Addendum No.: 4

Date of Addendum: June 17, 2020

Willard Diloreto Parking Garage
Paul Manafort Sr. Drive
New Britain, CT
CF – RC – 402

E-2 STAIR #3 - WEST ELEVATION
SCALE: 1/4" = 1'-0"

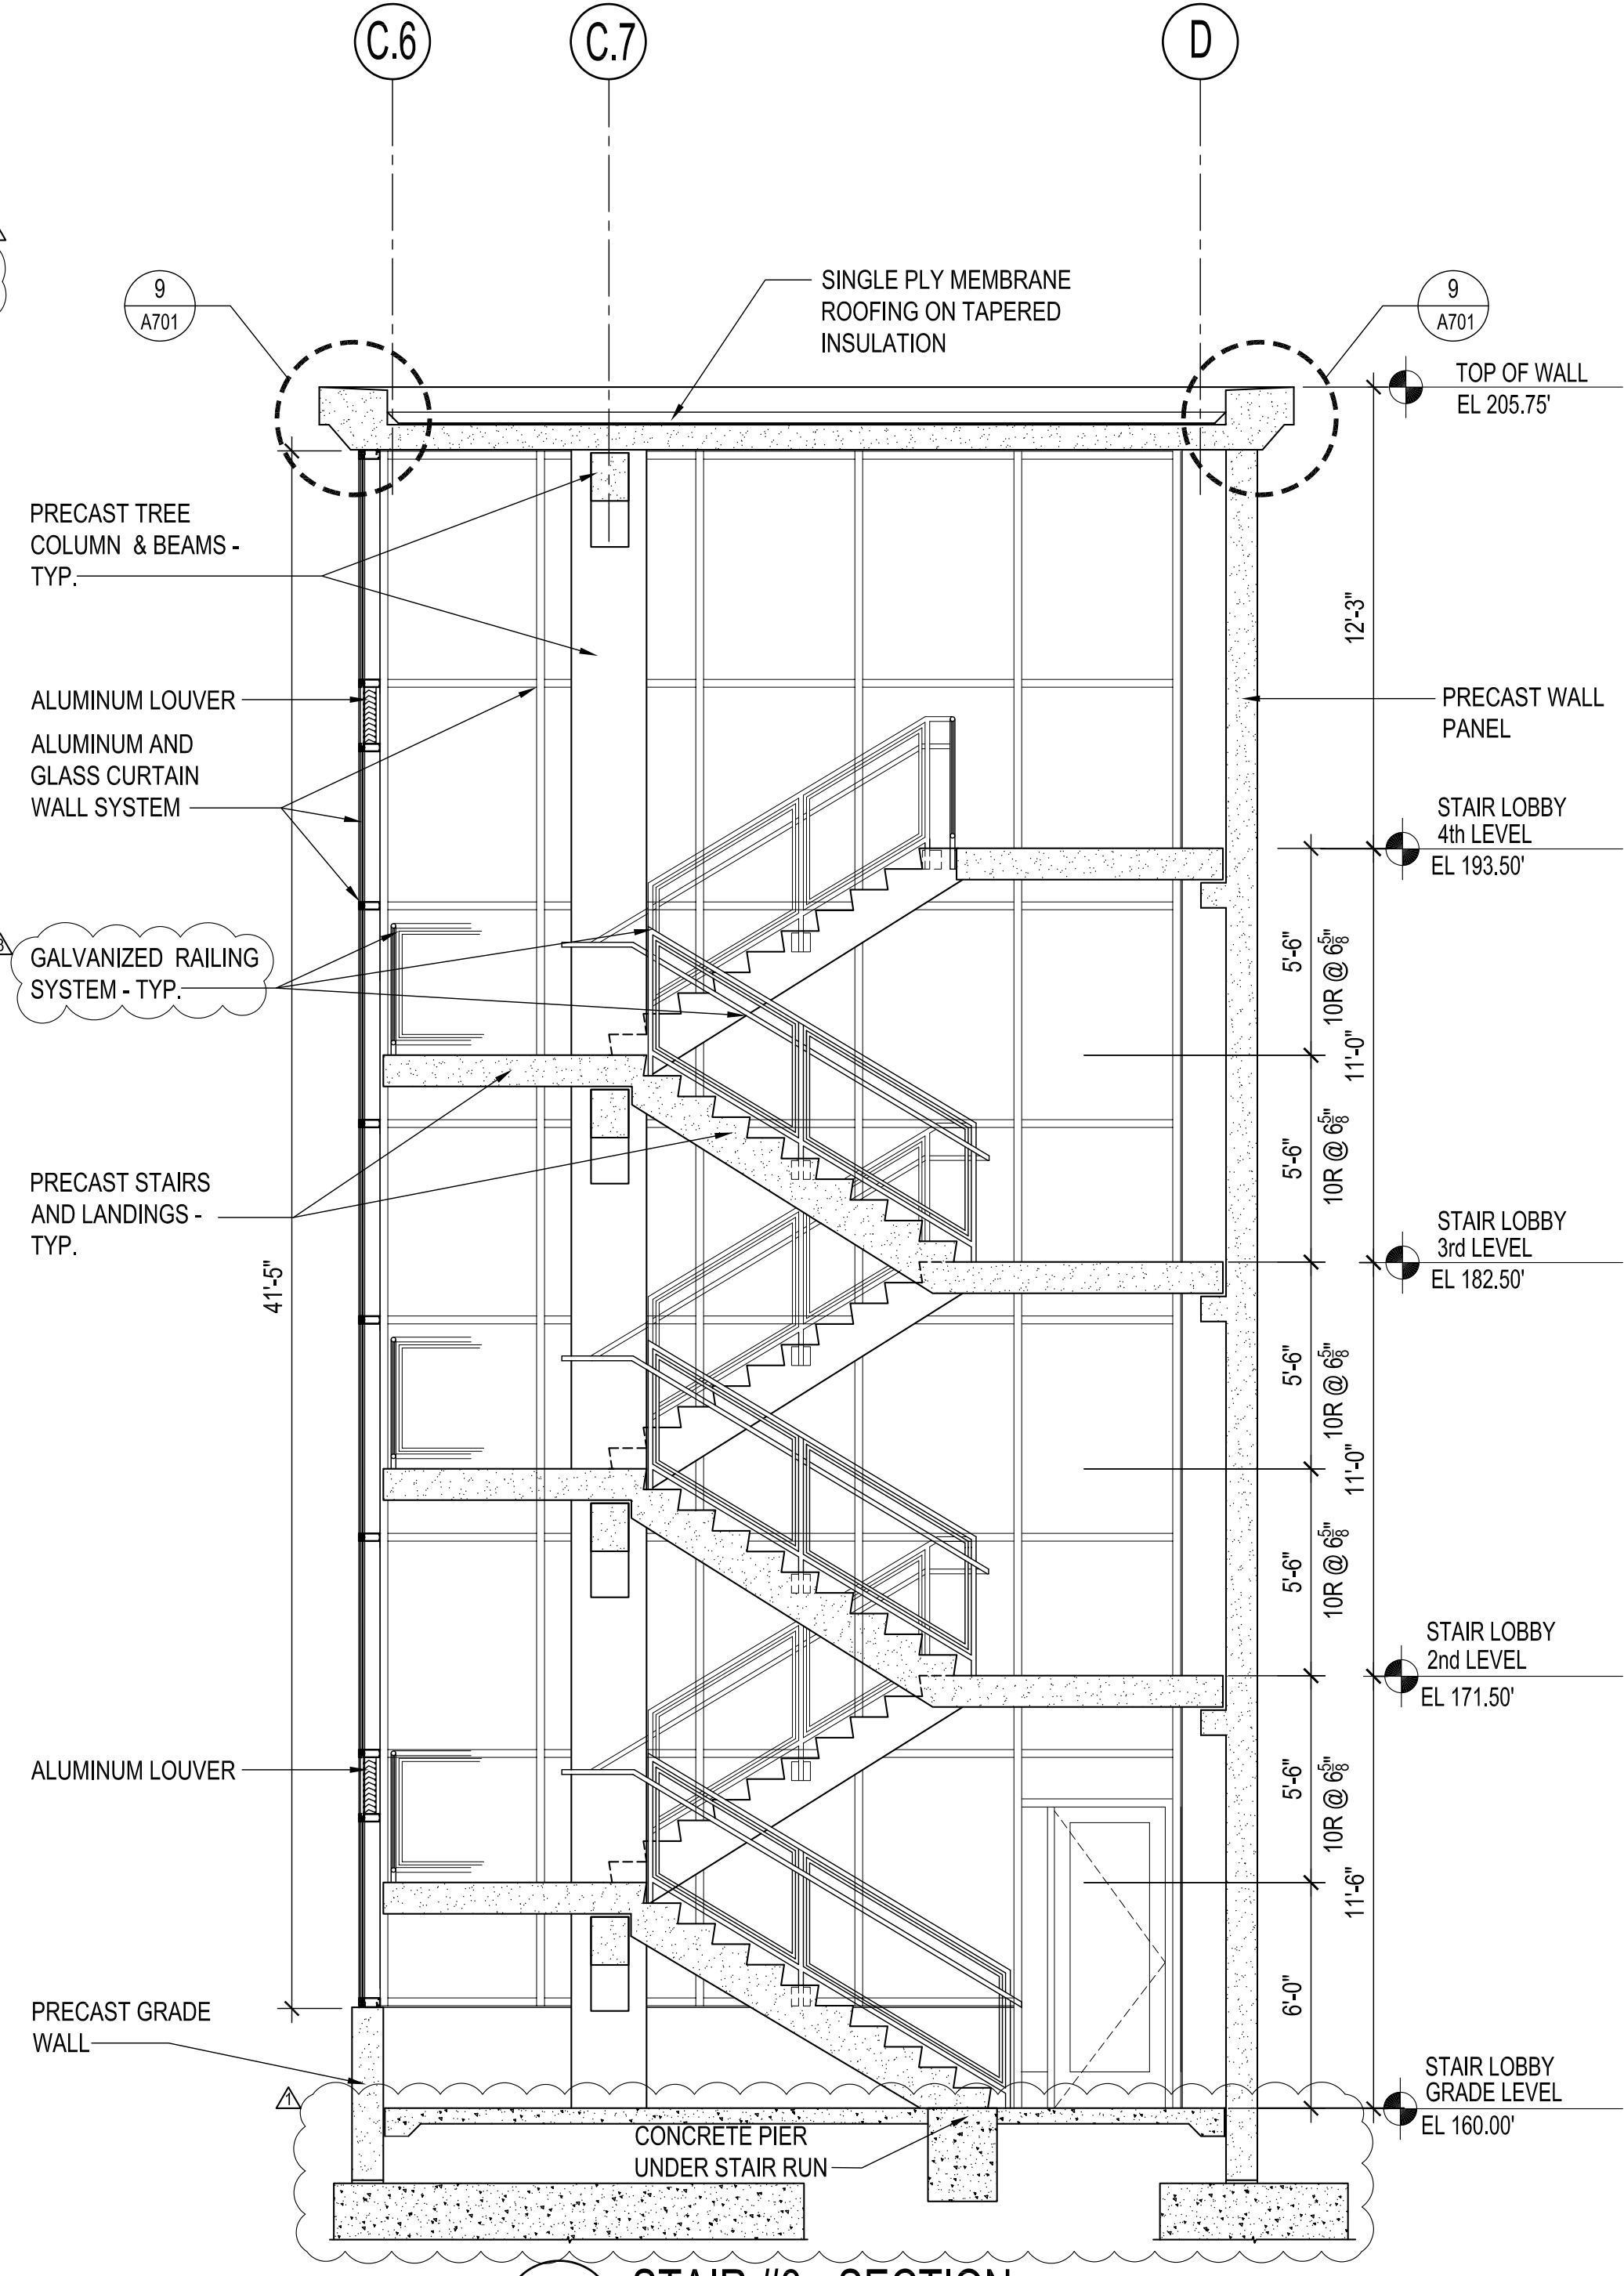
Question: Sheet A-503, Finish Legend - states that the stair guardrails are to be galvanized mesh screen with galvanized frames. The floor plans for each stairwell show them as galvanized also, the cross sections (A402, A405, & A407) have notes to paint the railing system. Is the galvanized guard railing (frame and mesh) painted in the field?

Answer: See revised stair section drawings A402, A405, A406 and A407. All railing systems are to be galvanized and not painted.

5 WALL SECTION
A602 SCALE: 3/8"=1'-0"

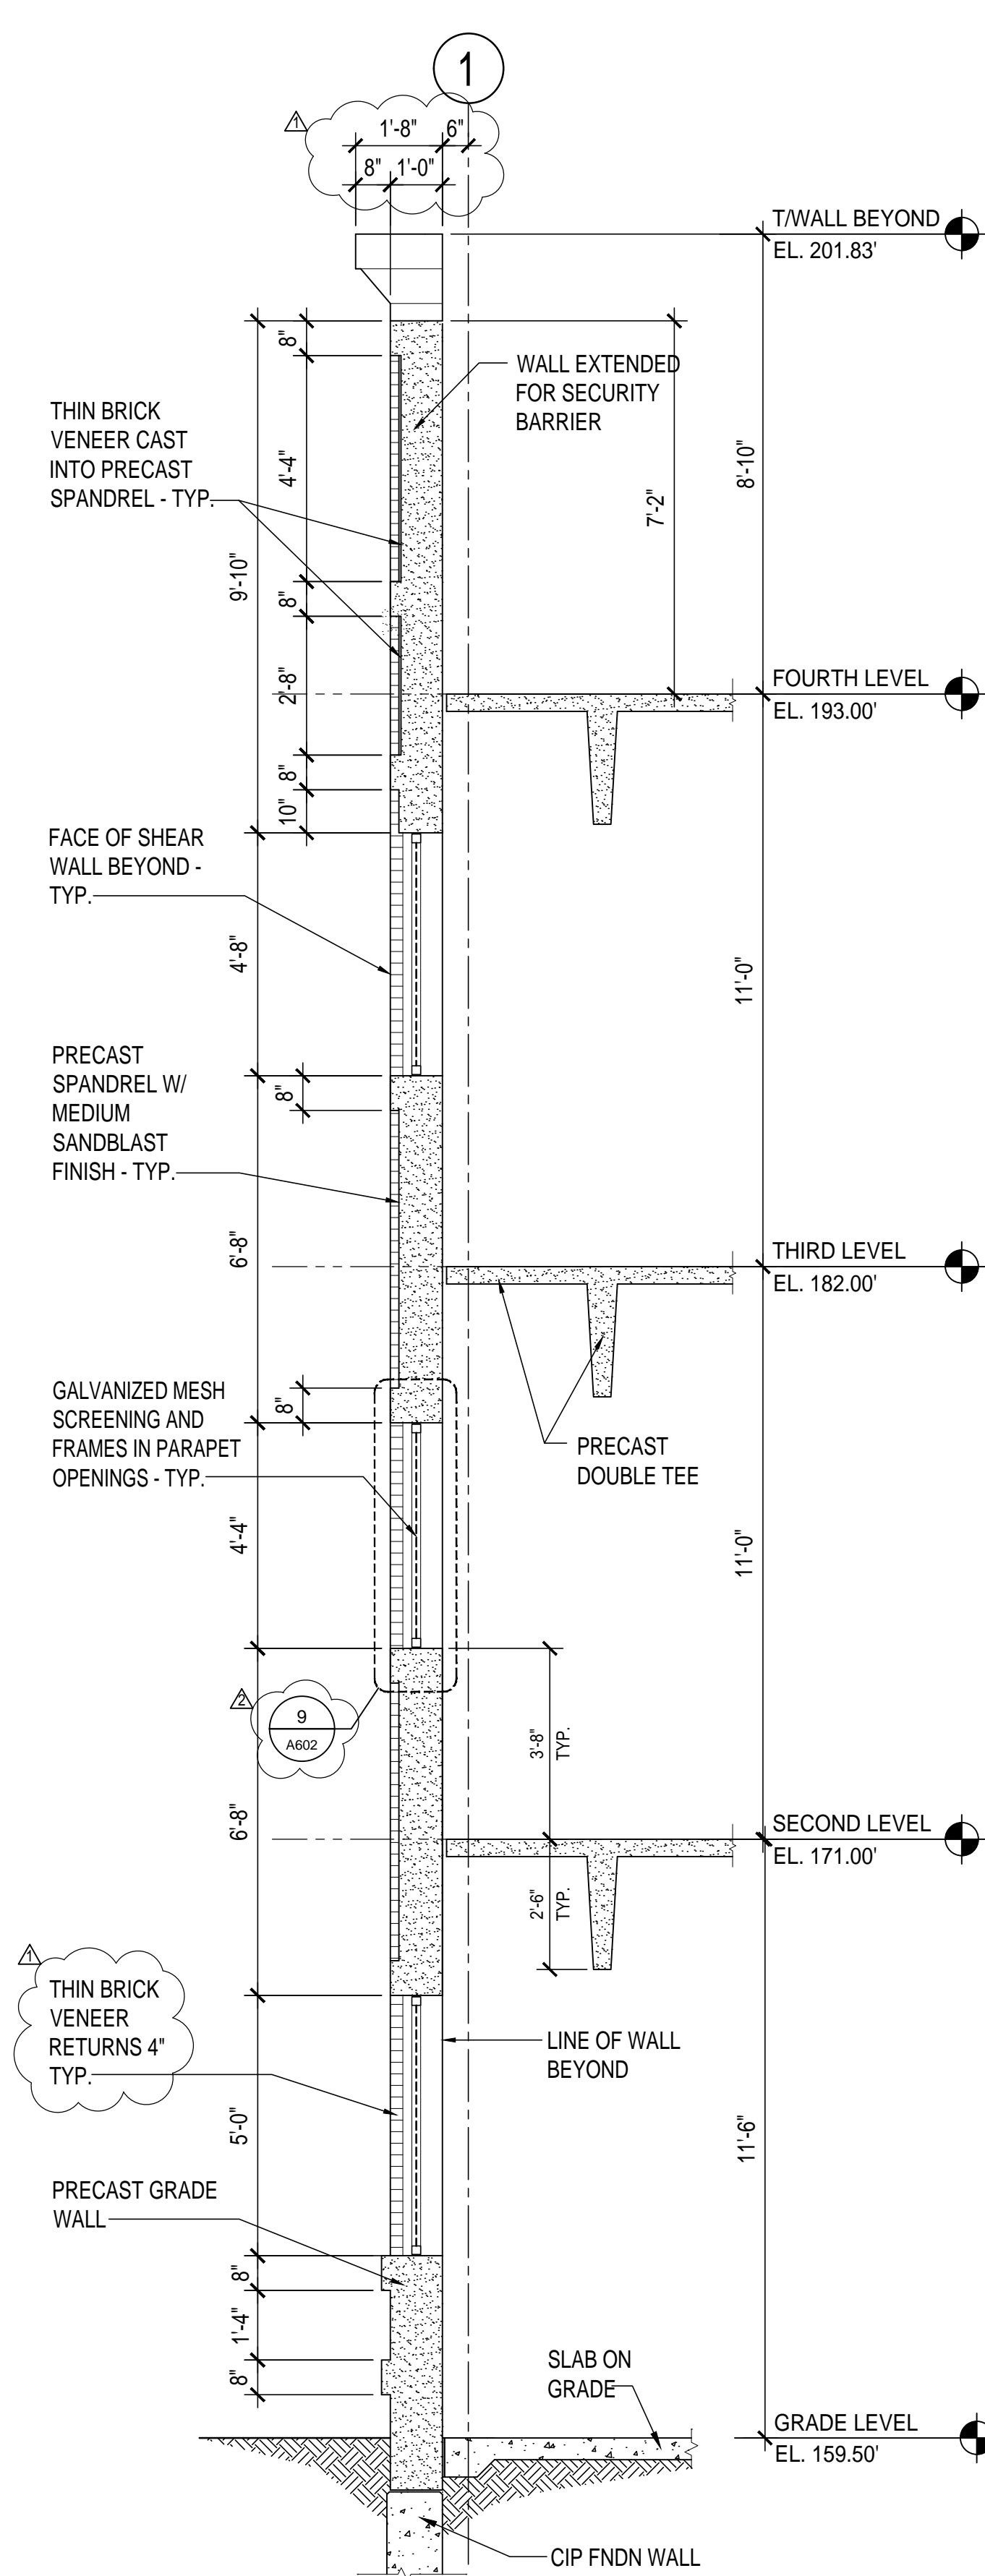
Question: Wall Section 5 / A602 calls for the mesh panels in parapet openings to be galvanized steel mesh in lieu of stainless steel mesh. Please confirm material.

Question: Please provide connection details for the stainless steel mesh screens and frames between parapet openings. See E2 / A201 & 5 / A602

Answer: See revised drawings A201 and A602 and revised specification section 05 50 00. Mesh panels are to be galvanized and not stainless steel.

Answer: See added details to revised drawing A602.

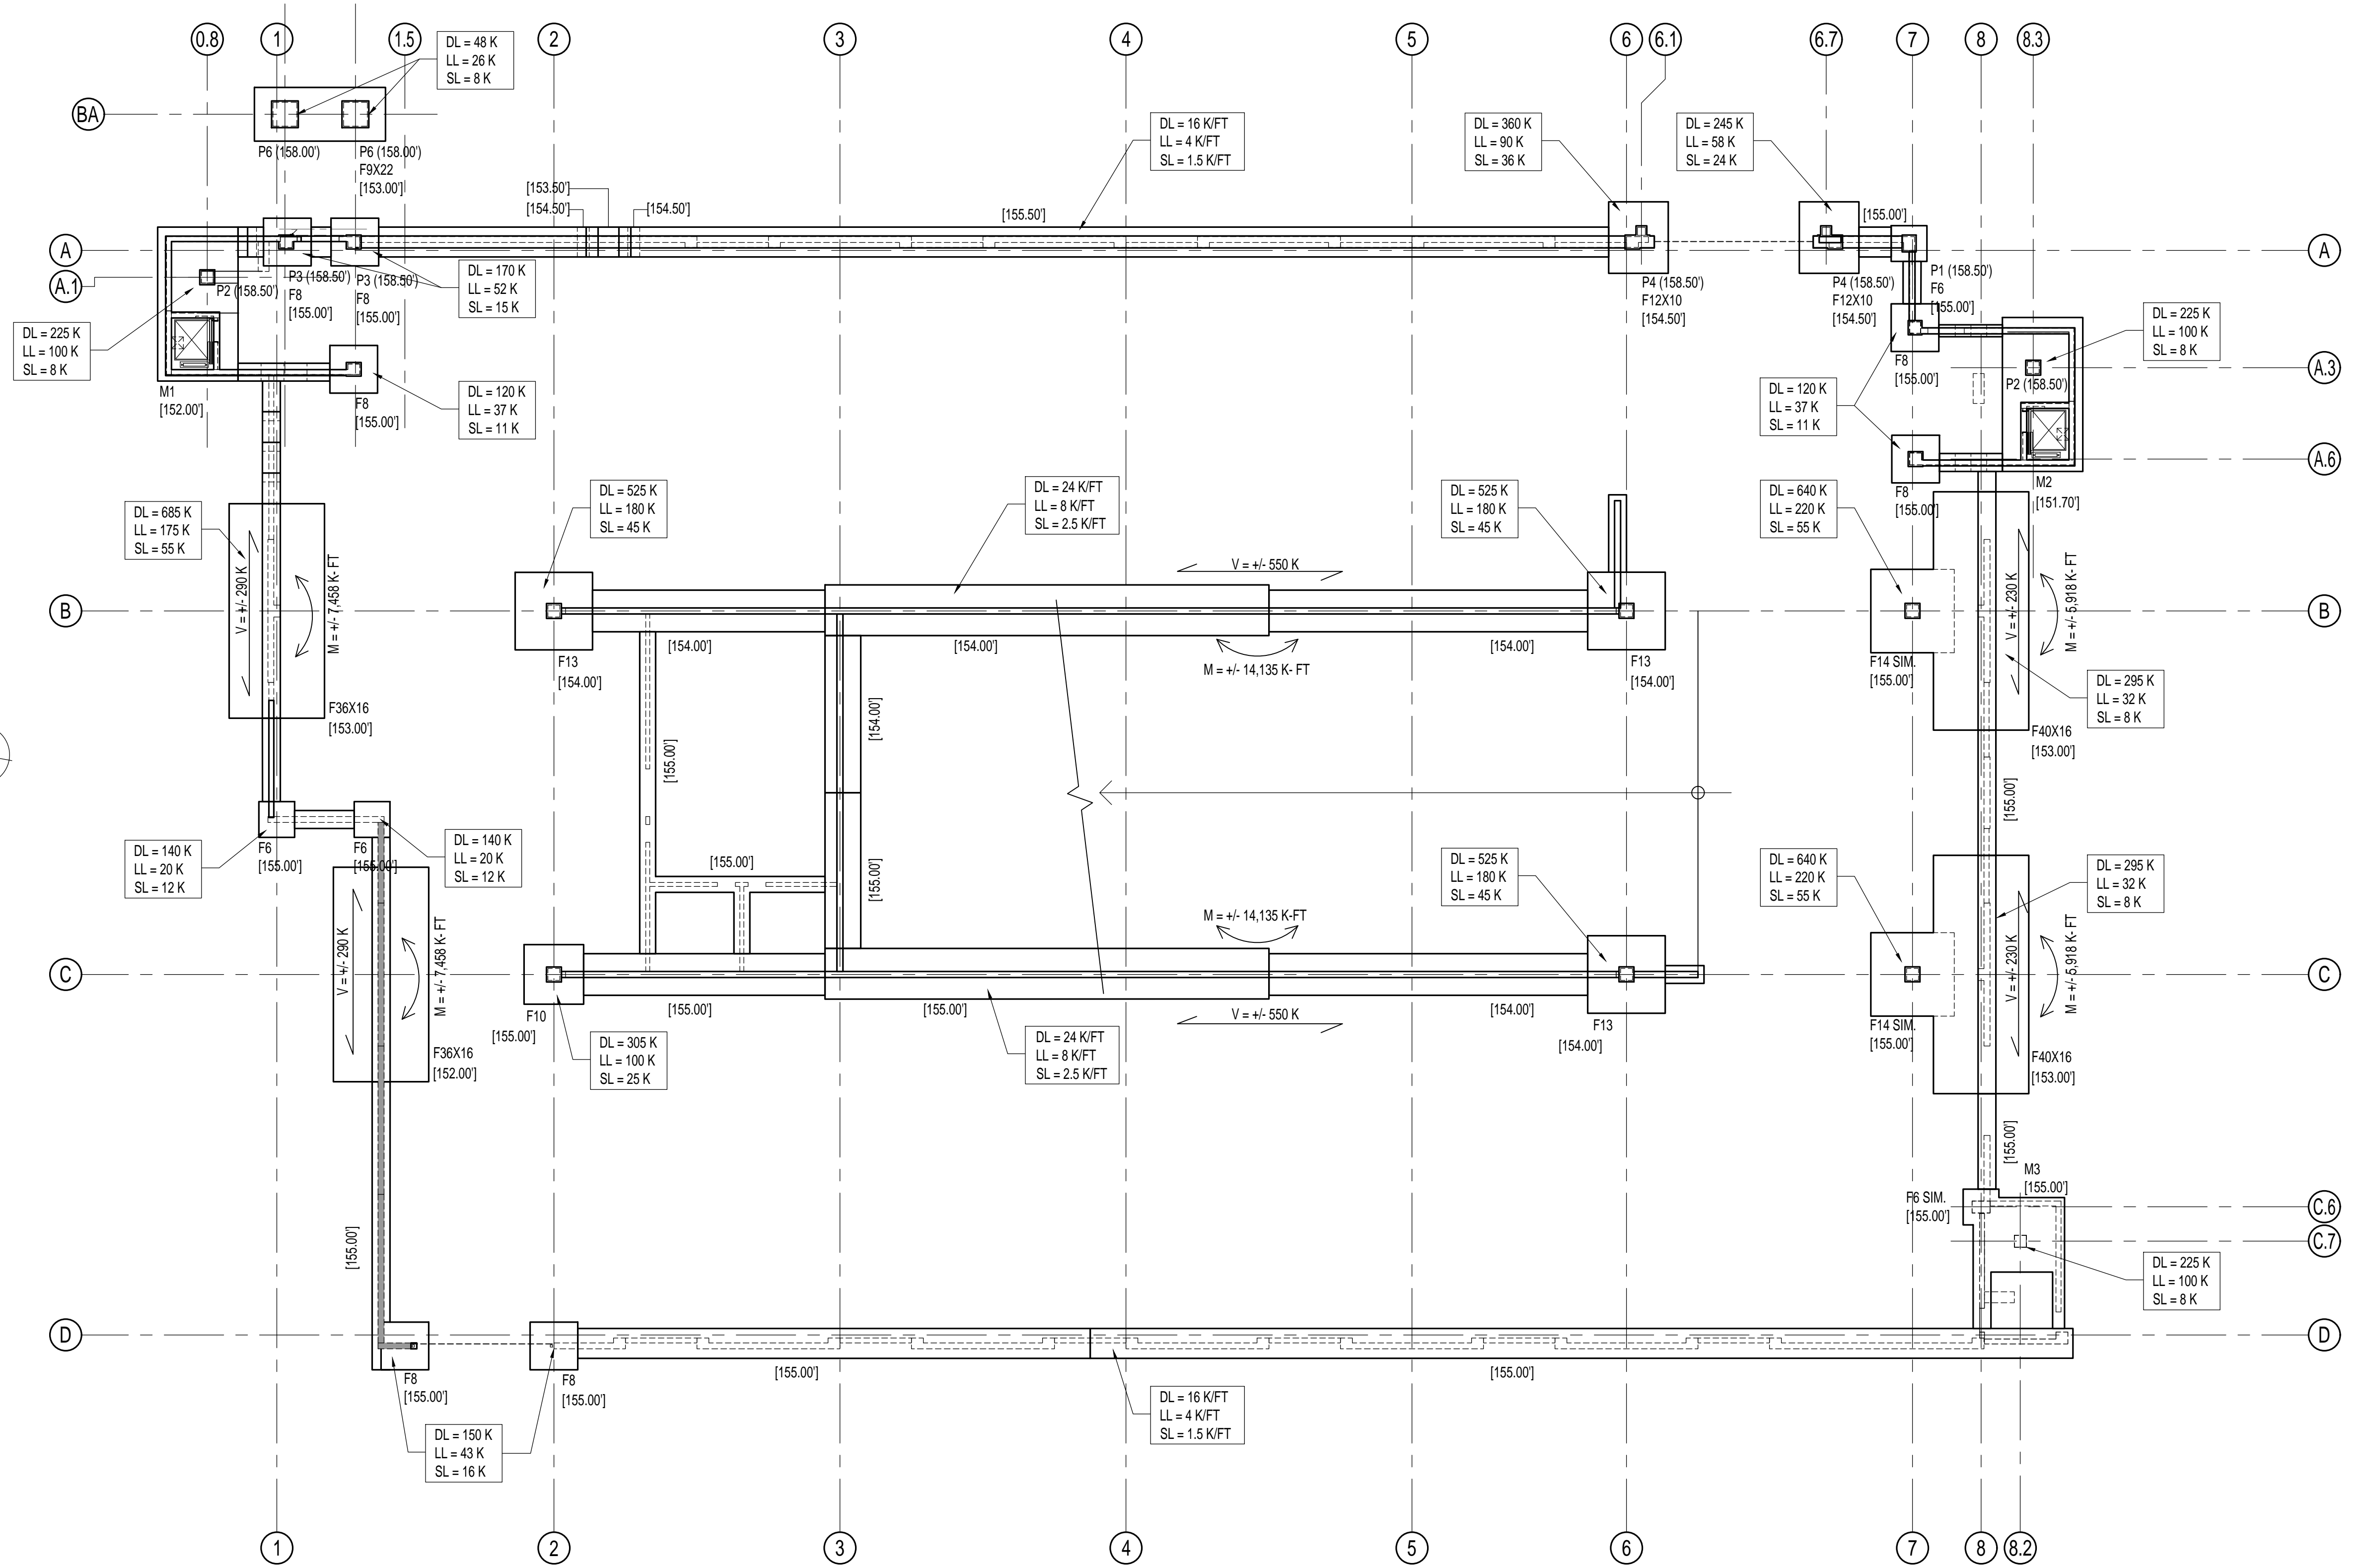
Question: Is it possible to get the following structural loads from the garage engineer? We'd like to get unfactored column base plate loads, wall loads, and pressures distribution under the large strip footings.

Answer: See added drawing S005 Loading Diagram indicating structural loads.
